| FED.ROAD DIST.NO. | STATE | PROJ. NO. | FISCAL YEAR | SHEET NO. | TOTAL SHEETS |
|---|---|---|---|---|---|
| HAWAII | HAW. | I-H3-1(72) | 1991 | ADD. 60 | 521 |

# GRADING PLAN
## H3 - KANEOHE INTERCHANGE
## STA. 333+62 TO STA. 344+00

# GRADING PLAN
## RAMP D
## STA.1083+57.76 TO STA. 1091+00

# GRADING PLAN
# RELOCATED LIKELIKE HIGHWAY
# STA. 0+00 TO STA. 9+00

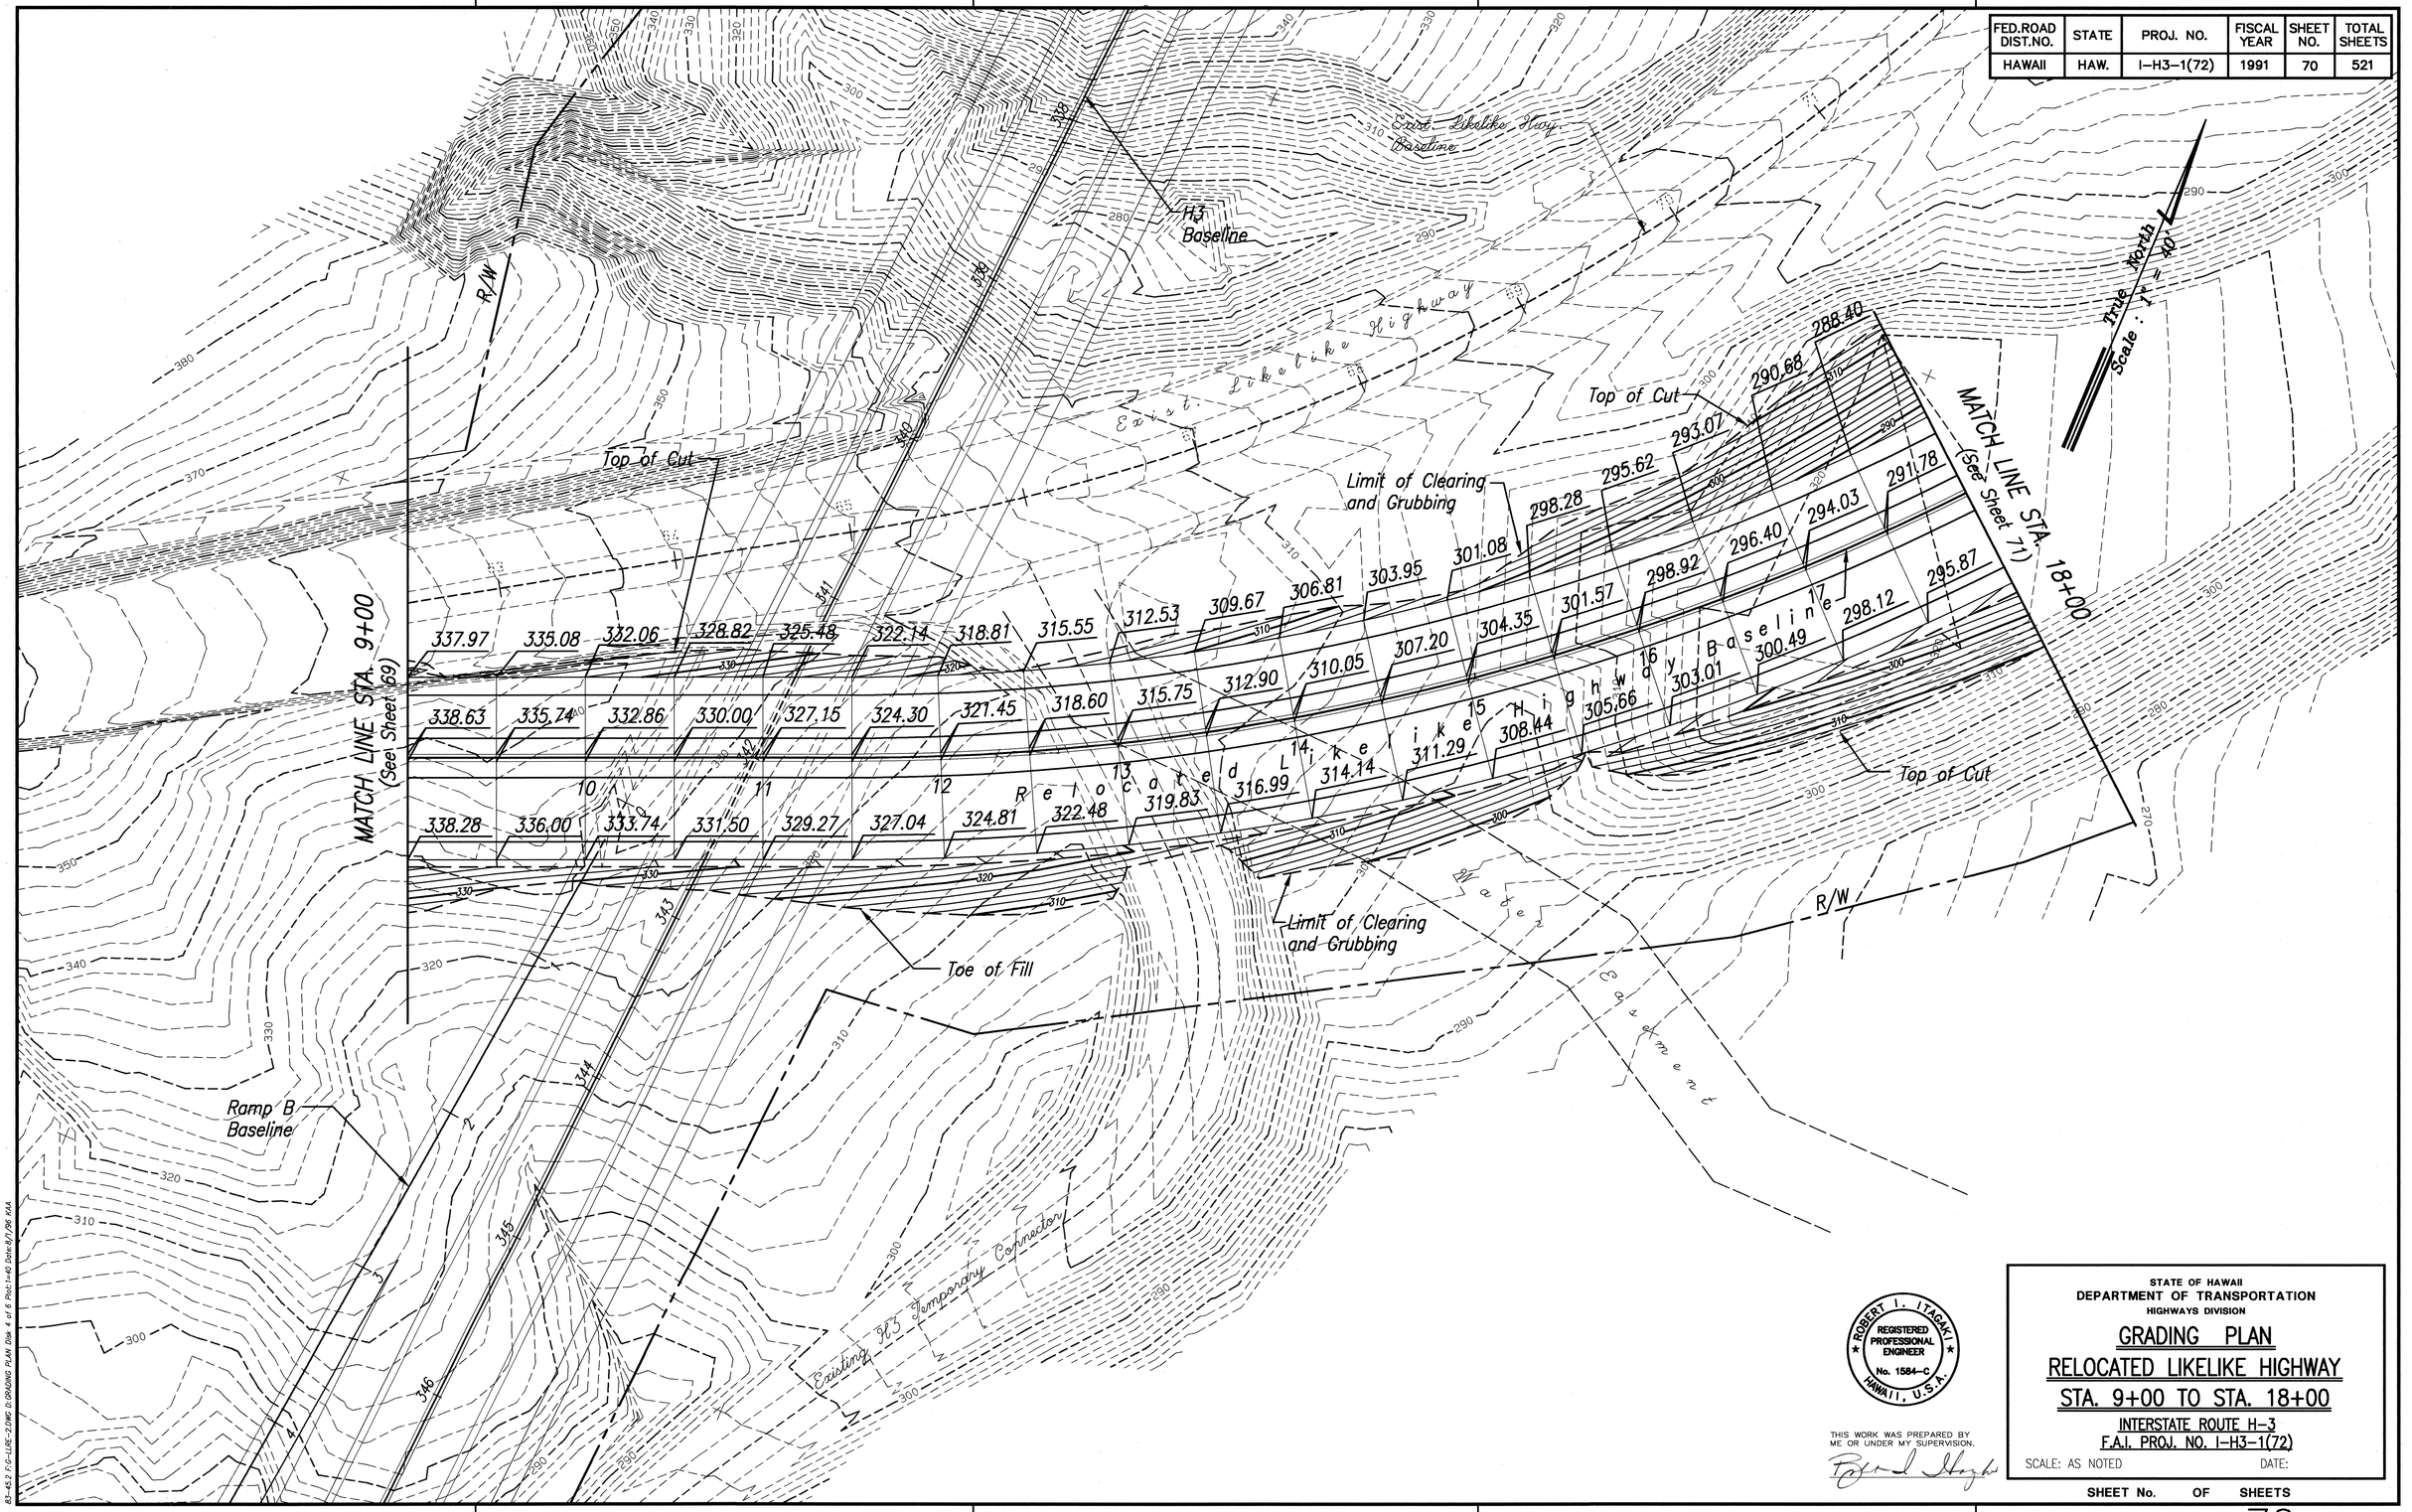
| DATE | REVISION |
|---|---|
| 4/10/95 | Revised Grades from Sta.0+00 to Sta.1+00, Inbound Shoulder Width and Grades from Sta.4+50 to Sta. 6+00, Deleted Energy Disspator @ Likelike Sta.1+58.15 and Added Inset and Headwall @ Sta.1+43. |
| 7/6/94 | Revised Grades within Smooth Connection Limits. |
| 6/1/94 | Revised Grading @ Ramp B Sta. 23+65 to Reloc. Likelike Sta. 0+25 and Retaining Wall Callout. |
| 12/15/93 | Revised Lined Trap. Ditch & Deleted Ditch Connection to Type 2 GDI @ Sta. 4+50. |
| 7/30/93 | Deleted Energy Dissipators and Added Retaining Wall |
| 5/26/93 | Extended Ditch and Revised Grading, (Minus Sta.) |
| 12/22/92 | Relocated Drainage Structure and Revised Drainage Ditch and Swale. |
| 3/27/92 | Added Lined Trap. Ditch<br>Revised Grading Sta. 0+00 to Sta. 4+00 Lt. Removed X Swale, Replaced With Appropriate Gutter.<br>Revised Right-Of-Way |
| 2/21/92 | Revised Energy Dissipator Alignment |

# GRADING PLAN
## RELOCATED LIKELIKE HIGHWAY
## STA. 18+00 TO STA. 27+00

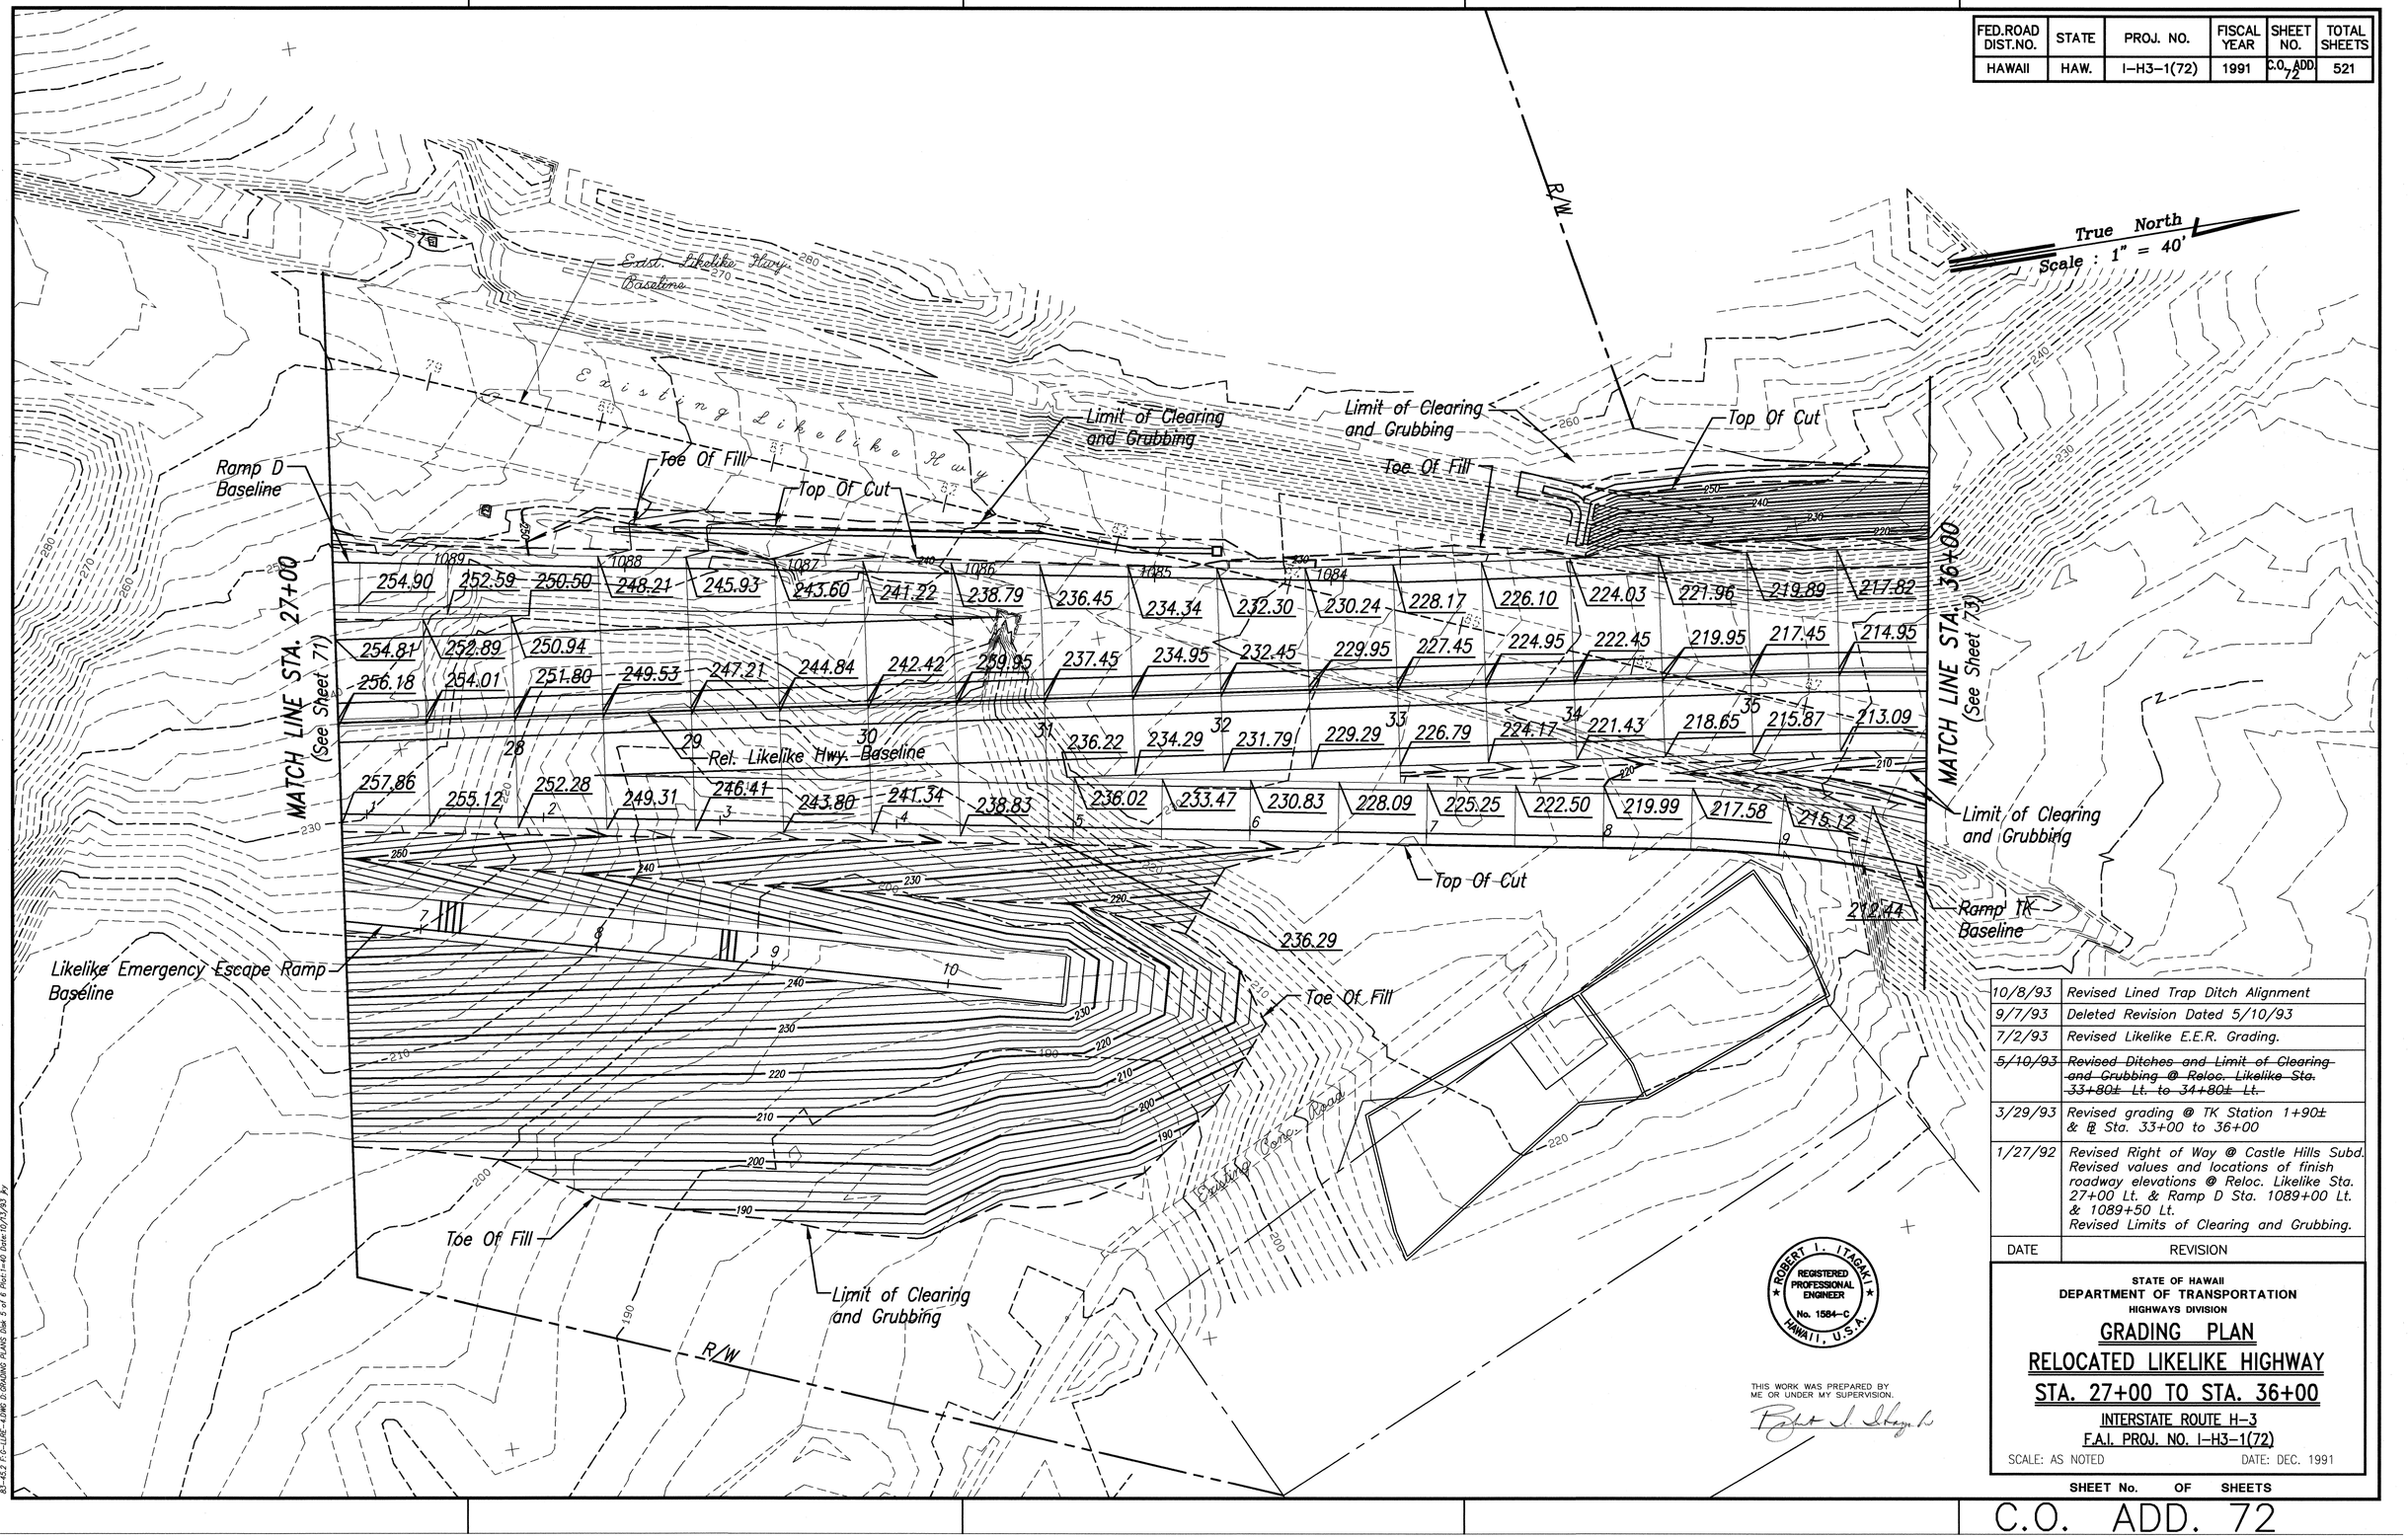
| DATE | REVISION |
|---|---|
| 7/30/93 | Revised Likelike E.E.R. Grading |

# GRADING PLAN
## RELOCATED LIKELIKE HIGHWAY
## STA. 36+00 TO STA. 45+00

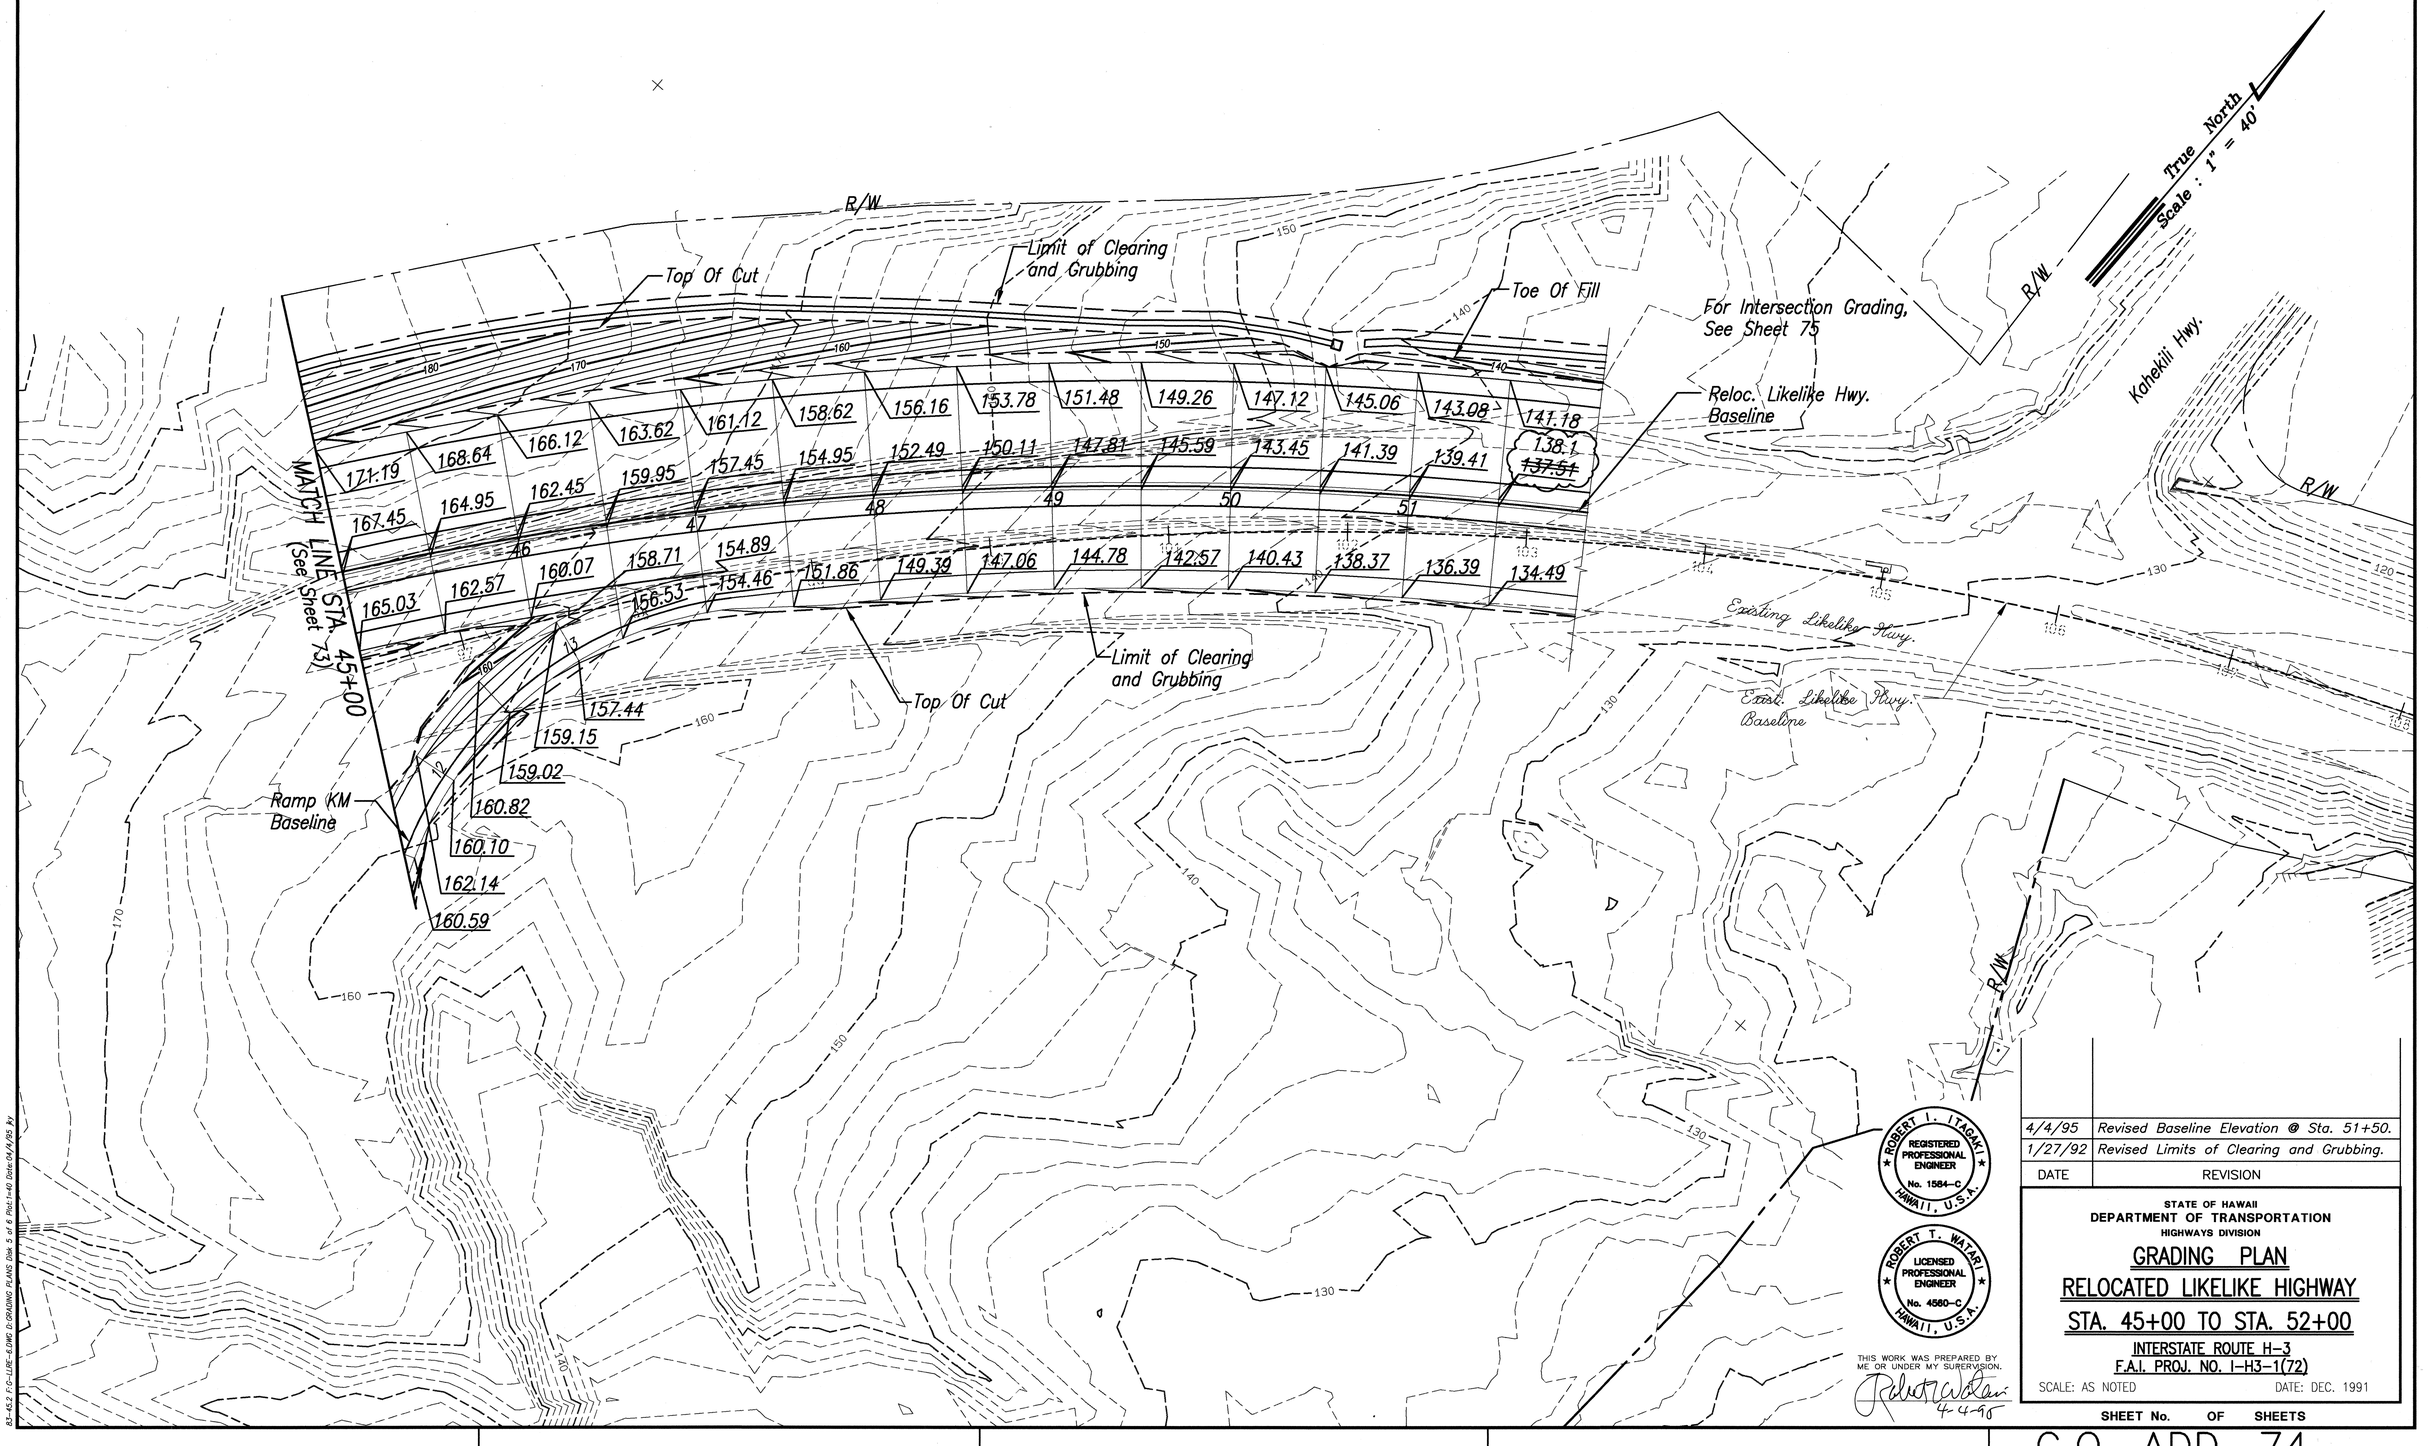
| 7/7/95 | Revised Median Finish Grades from Sta. 40+31± to Sta. 41+77±. |
| 1/27/92 | Revised Right of Way @ Castle Hills Subd. Revised Limits of Clearing and Grubbing. |
